## NEENAH PLAN COMMISSION

**DATE:** April 23, 2024  
**TO:** Mayor Lang and Plan Commission  
**FROM:** Brad Schmidt, AICP, Deputy Director  
**RE:** Site Plan Review – 1750 Dixie Road – RGL Logistics

**RE: Site Plan #4-24 - 1750 Dixie Road - RGL Logistics Site Plan - Major Review ( ) Status Conditional**

Date: 04-10-2024  
Address: RGL Warehouse Development  
1712 Dixie Road, Neenah

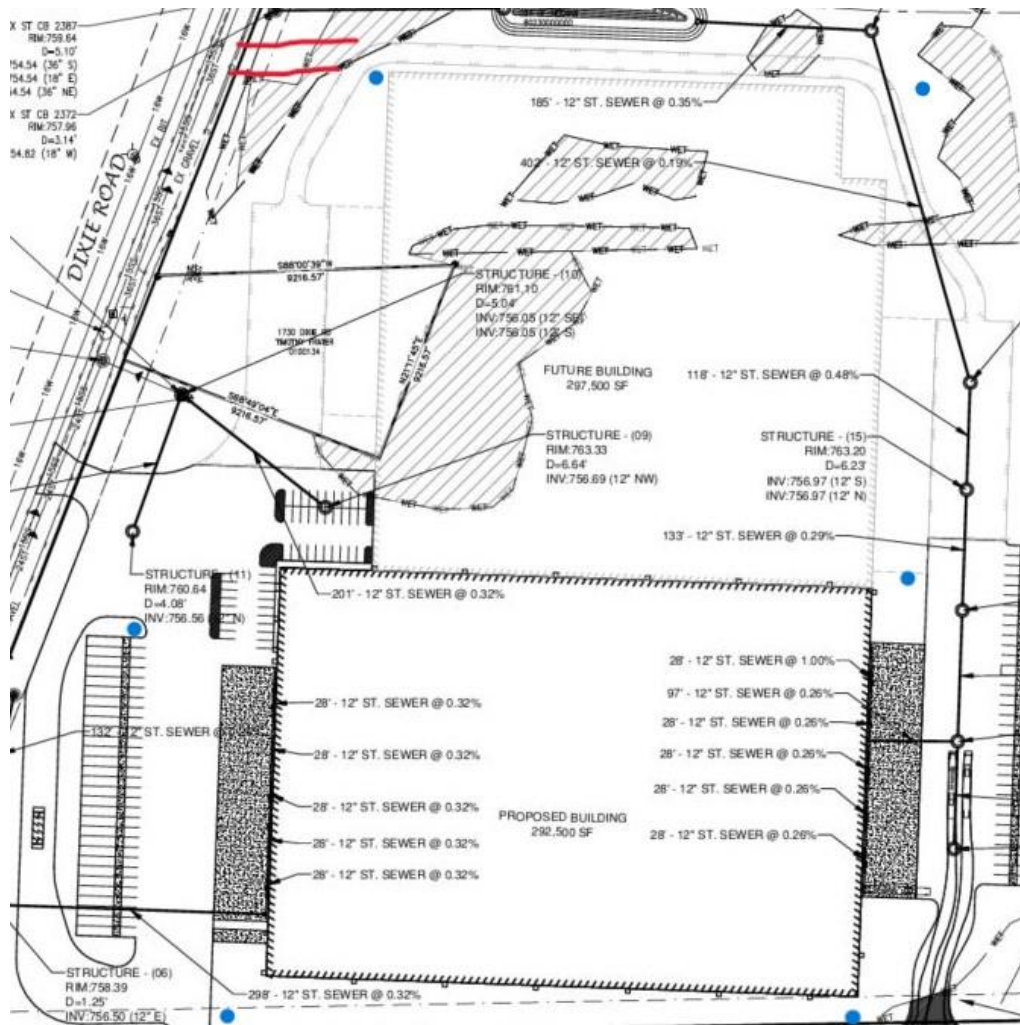
- c. A fire hydrant needs to be installed within 100 feet of the fire department connection.
15. An additional entrance to the fire lane shall be planned for on the north end of the future addition, off Dixie Road. This area is marked with red lines on the attached photo.

16. The additional hydrants to be added are marked with a blue dot on the attached photo.
17. A fire hydrant needs to be installed within 100 feet of the fire department connection.

File: P:\35001\5435\5435019\443\5435019A.dwg  
 Plot Date: Apr 24, 2024 11:23:00am  
 SITE PLAN  
 LAYOUT:

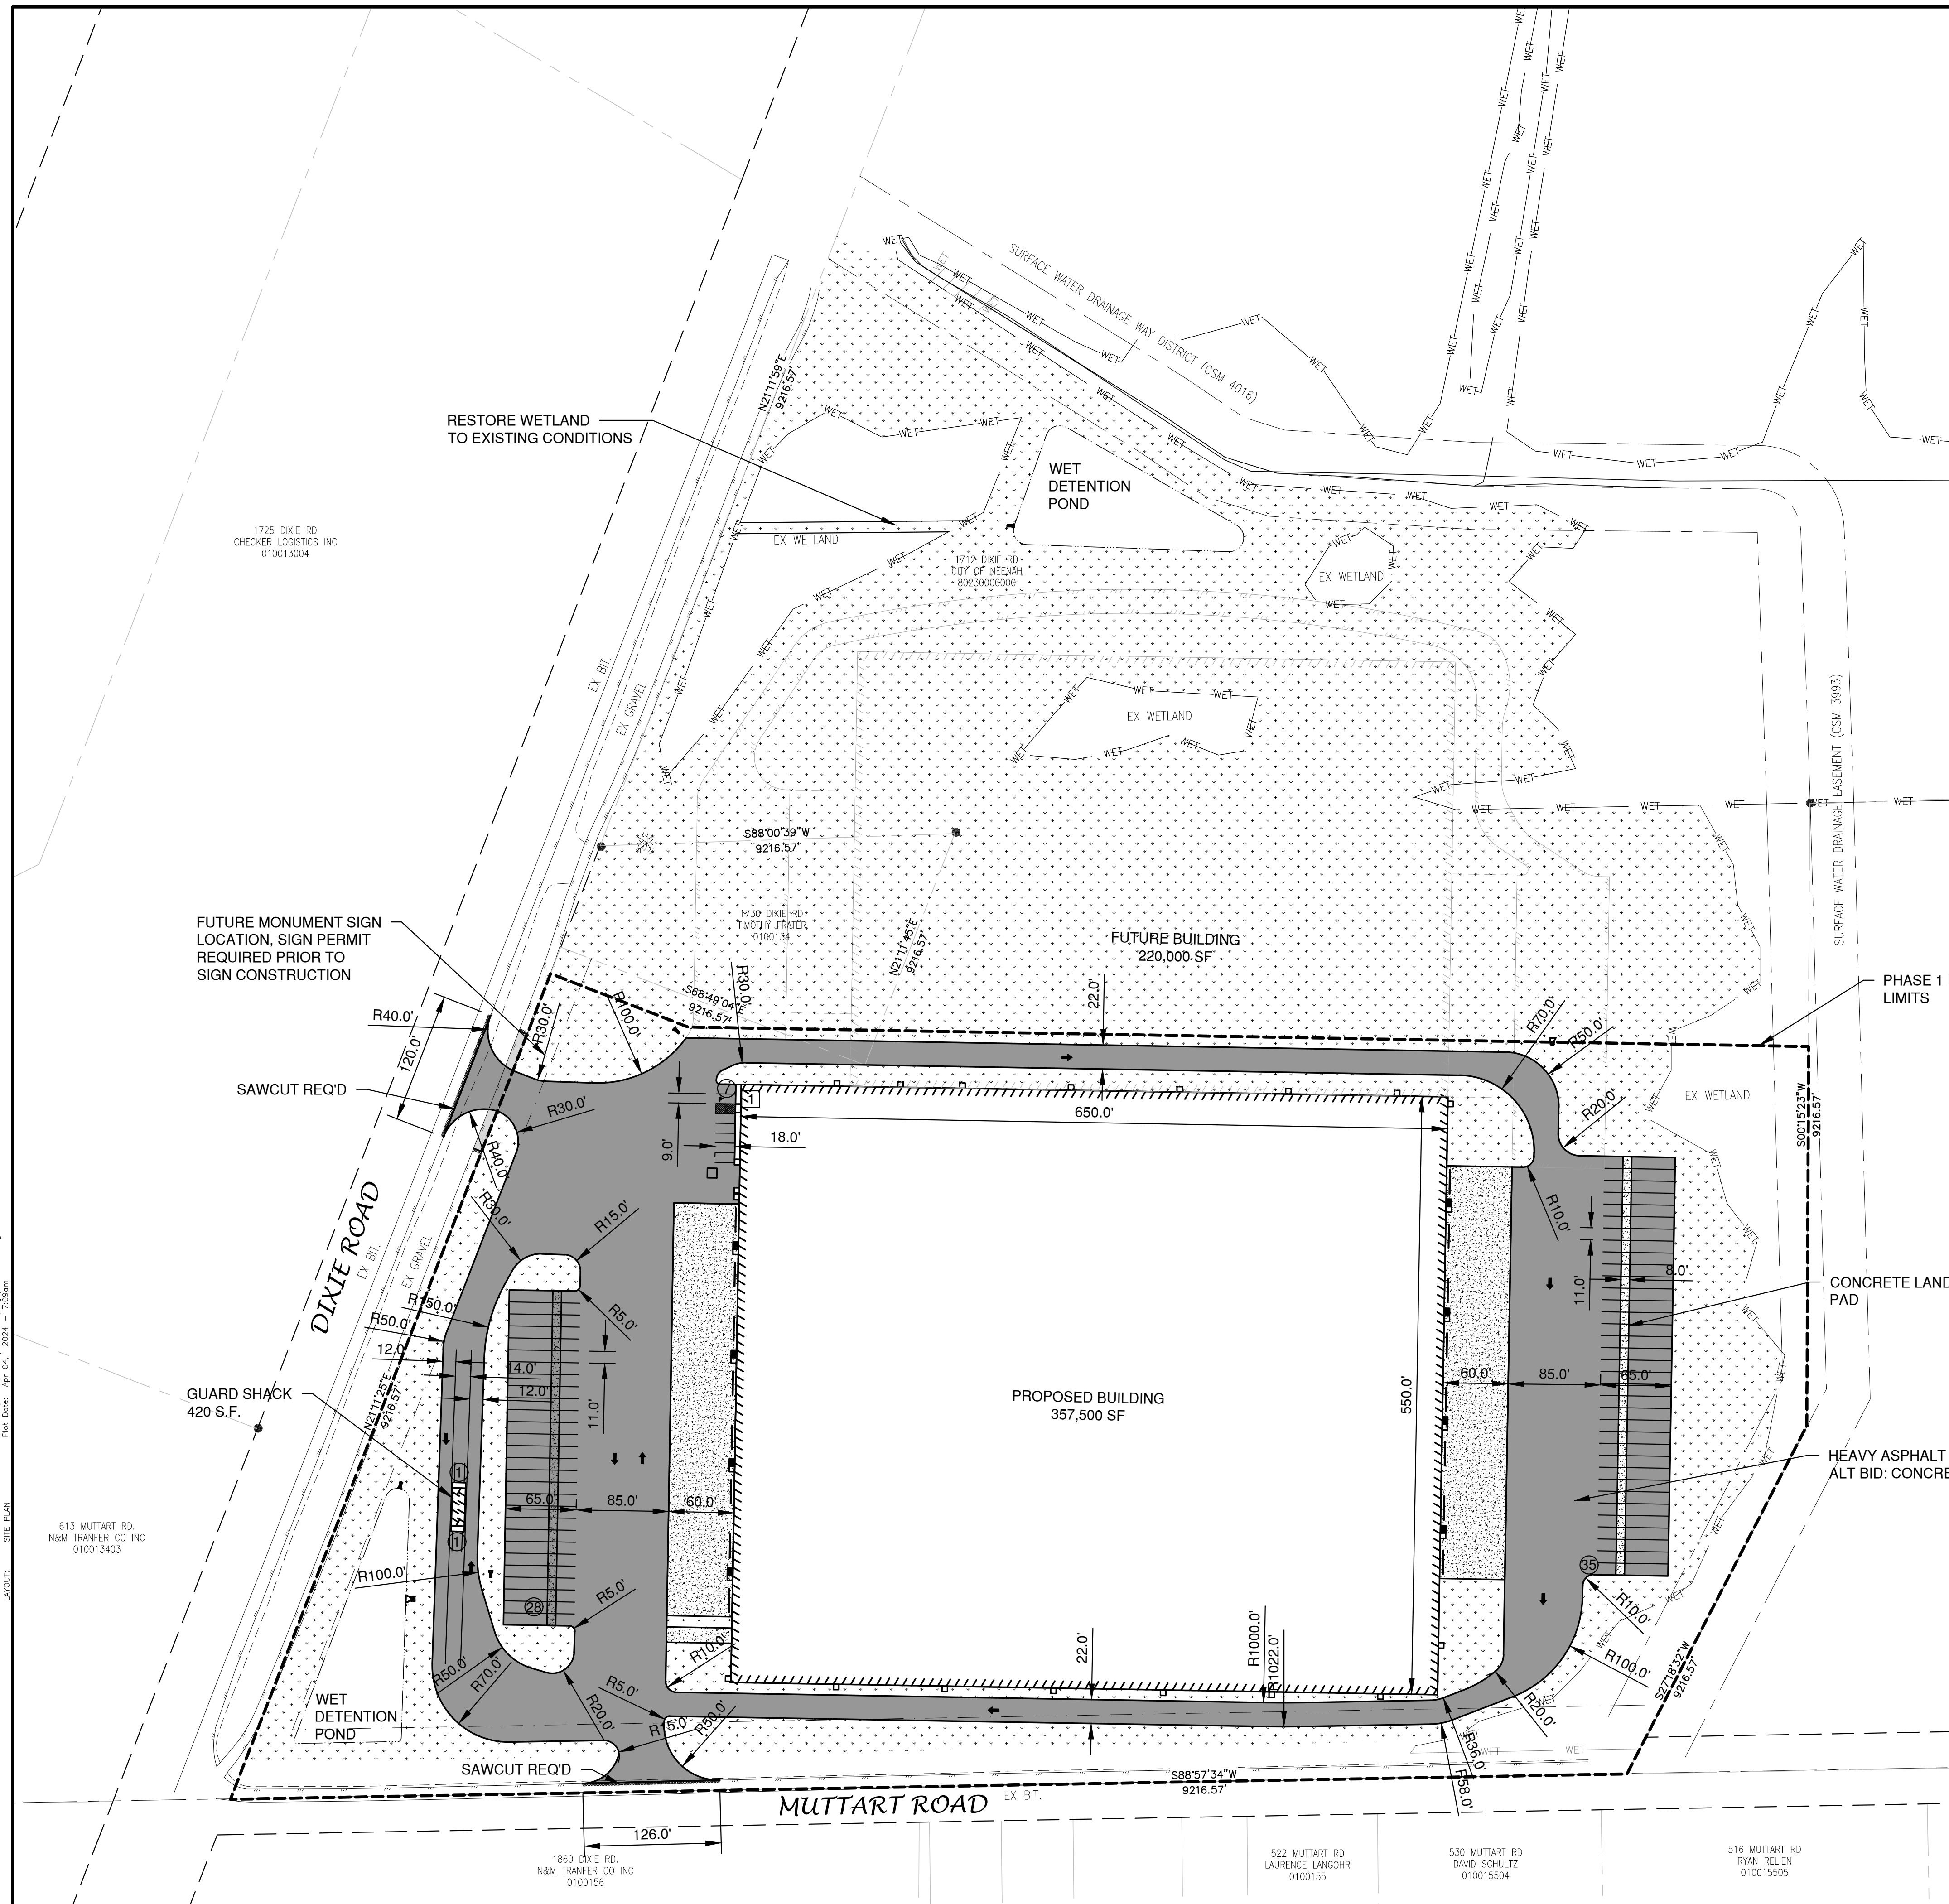
13. Fire Lanes:
  - a. Fire apparatus access roads must comply with Section 503 of the 2024 International Fire Code.
  - b. It is highly recommended that the fire lane shown on sheet number 2, of the plans submitted to the City of Neenah for site plan review, located on the south side of the building be eliminated.
